**AMENDMENTS TO THE DRAWINGS:**

**REMARKS**

In the Final Office Action mailed March 3, 2009, the Examiner took the following actions:

Fig. 9

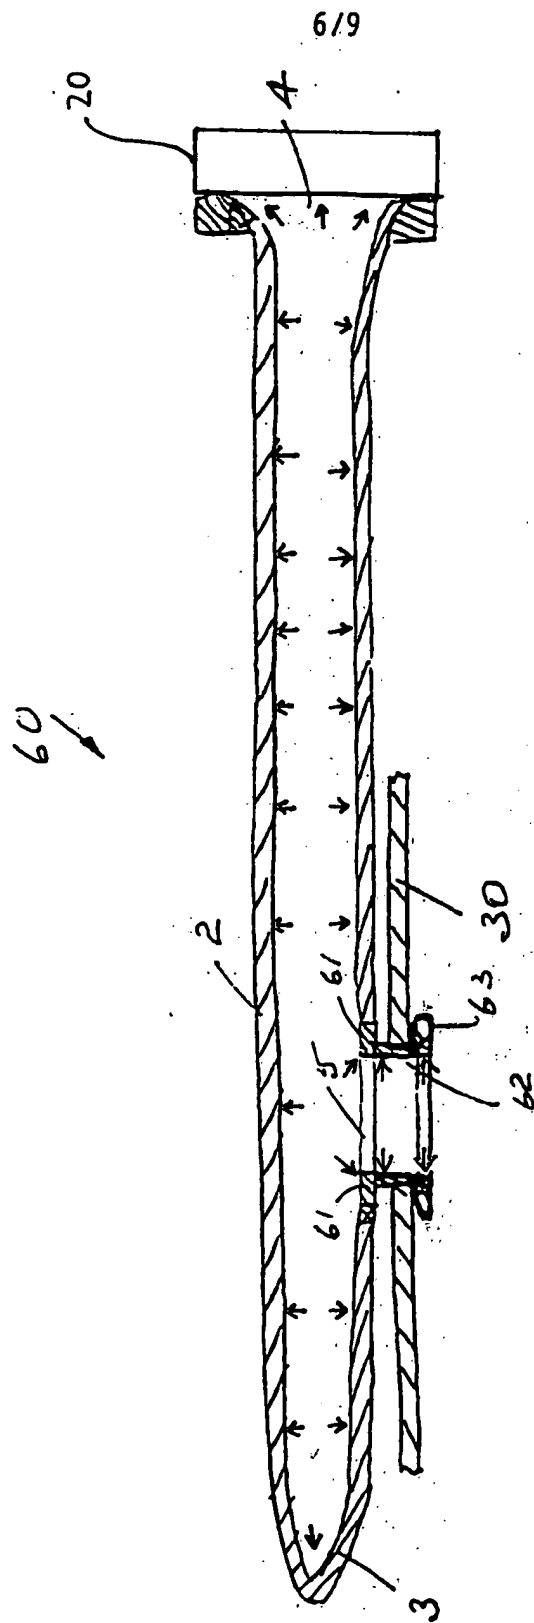
The attached replacement drawing sheet includes amendments to FIG. 9. Those amendments include adding the element identified using reference numeral 20, as well as adding arrows in an interior region of the element identified using reference numeral 2. The attached annotated sheet shows the amendments in redline.

On page 8 of the Office Action, the drawings were objected to under 37 C.F.R. § 1.83(b) as allegedly being incomplete. According to the Examiner's comments in the Interview Summary, and on pages 2 and 9 of the Office Action, the proposed amended version of FIG. 9 that was presented at the interview remedies the alleged drawing deficiencies, and is supported by the originally-filed application. The attached Replacement Drawing Sheet is based on the proposed amended version of FIG. 9, and thus, it remedies the alleged drawing deficiencies. Accordingly, Applicant requests reconsideration and withdrawal of the drawing objection.

On page 9 of the Office Action, the specification was objected to as allegedly failing to provide proper antecedent basis for the claimed subject matter. In accordance with page 9 of the Office Action, the attached Replacement Drawing Sheet remedies the alleged specification deficiencies associated with the phrases "an entry seal assembly," "controlled pressurized environment inside the surgical device," and "distal ring," recited in the claims. Claims reciting the phrase "primary coupling" have been canceled by this Amendment, rendering the objection to that phrase moot. Accordingly, Applicant requests reconsideration and withdrawal of the objection to the specification.
